REVIEW OF EAST LAKE – FYSHWICK STP ODOUR STUDY REPORTS

Lolita No 1 and Lolita No 2 Pty Ltd c/- Molonglo Group

Job No: 6791

19 April 2012

Figure 3.1: Buffer Requirements for mechanical/biological waste water treatment

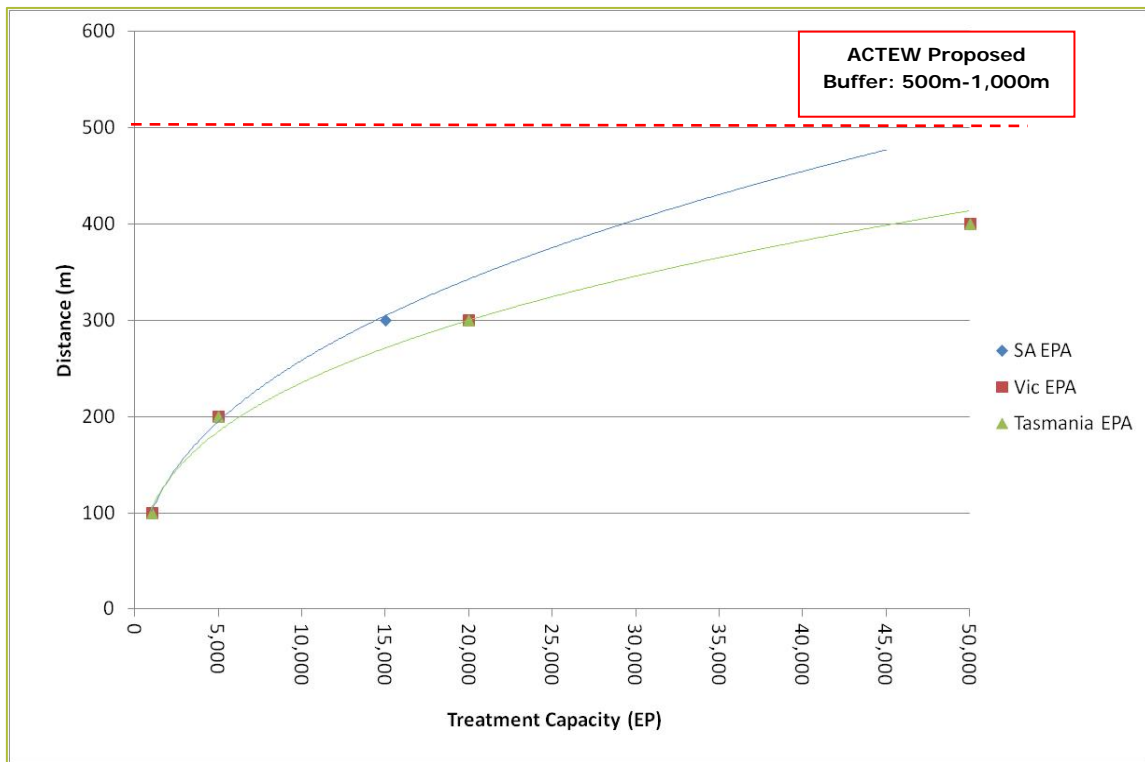
Evaluation of **Figure 3.1** indicates that the ACTEW proposed buffer zone is not supported by comparison to other buffer distance guideline documentation.
